Addendum #1 IDNR Project E090097 Jackson/Washington State Forest Parking Lot Paving Improvements

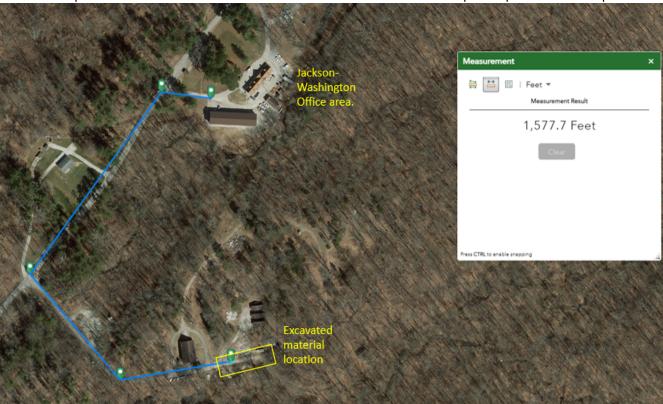
- 3. All forms in the Bid Packet shall be completed for the bid to be accepted.
- 4. The depth of the existing asphalt over the entire lot is unknown and may vary. In 2009 a sidewalk was poured against the office building. See picture below for asphalt depth in this area and note the dowel rods. A question was asked regarding length of saw cut. The contractor shall use best judgment in determining the length of saw cut that may be required and include in the lump sum bid for the project. DNR indicates that they believe dowel rods are spaced out along the length of the building.
